Line-by-Line Response by M.Z. Jacobson, M.A. Delucchi to

Evaluation of a proposal for reliable low-cost grid power with 100% wind, water, and solar

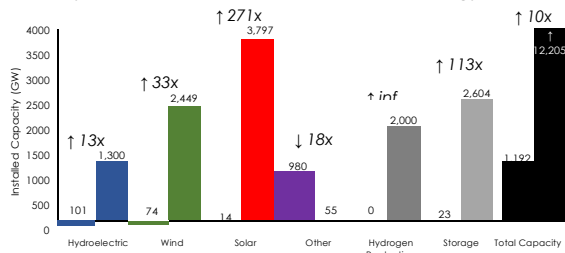
The energy storage capacity consists almost entirely of two technologies that remain unproven at any scale: 514.6 TWh of underground thermal energy storage (UTES; the largest UTES facility today is 0.0041 TWh; further discussed in Section S2.1 of our SI Appendix), and 13.26 terawatt-hours (TWh) of phase-change materials (PCM; effectively, in research and demonstration phase; further discussed in Section S2.2 of our SI Appendix) coupled to concentrating solar thermal power (CSP). To give an idea of scale, the 100% wind, solar and hydroelectric power system proposed in ref. [11] envisions underground thermal energy storage (UTES) systems deployed in nearly every community for nearly every home, business, office building, hospital, school and factory in the United States, while only a handful exist today.

(28) See response (16).

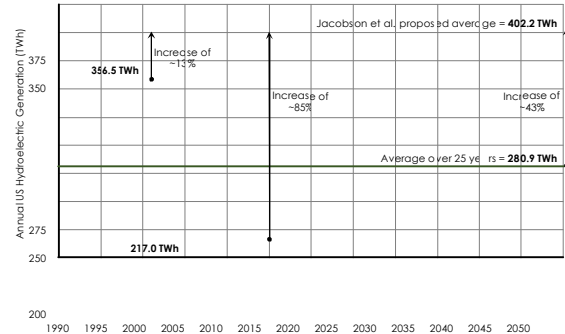
To illustrate the implausibility of the assumed increase in hydroelectric net generation (dispatched from the plants to the electricity grid) in the face of limited water supply, we plot in

(35) Figure 3 of C17 is a false comparison because it compares U.S. hydropower output from “data” provided by C17 with U.S. plus imported Canadian hydropower output from Jacobson et al. (2015). Thus, C17 show apples versus oranges, failing to point out clearly the difference in numbers in the figure itself or the figure caption. The comparison should never have been made. The Canadian portion of the 402.2 TWh from the Jacobson et al. studies (Refs 11 and 12 of C17) is 45 TWh, or 11.2% of the total. Subtracting 45 TWh from 402.2 TWh gives 357.2 TWh, which is only 0.2% different from the 356.5 TWh historic maximum listed in Figure 3 of C17, not 13% higher. And again, the 1,300 GW peak power for hydro with an annual average hydro power output of 87.5 GW (not 150 GW) of capacity is possible as explained clearly under Response (24).
